S33255 – Flannagan

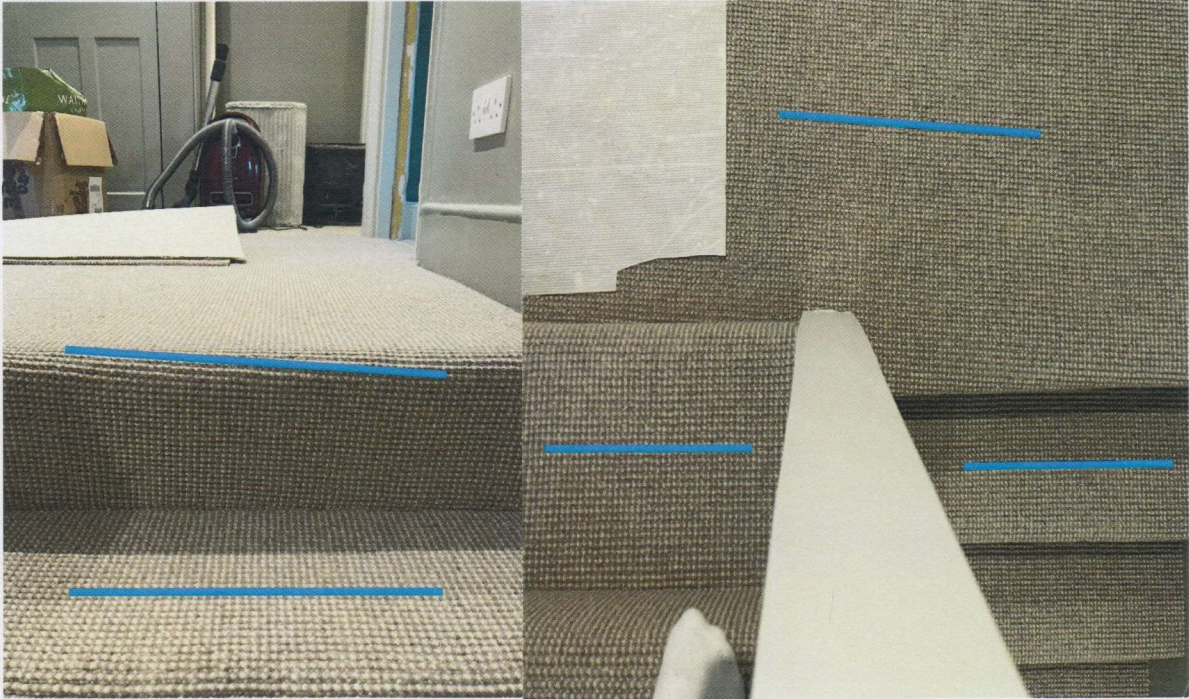
Main Landing is laid wonky, requires replacing

Seam on Main Landing to be improved. When the Main Landing is replaced, please re-do the main landing seam as far away from the bathroom doorway as possible

Top two stairs on this flight and a few others require lifting up and having the overhanging underlay trimmed. On 90% of the stairs it seems that the underlay finishes on edge of nosing, causes no bulging and looks good, whereas the steps where the underlay folds over and not secured in place is trying to take its original shape and makes the carpet bulge. I have marked the bulge lines with yellow.
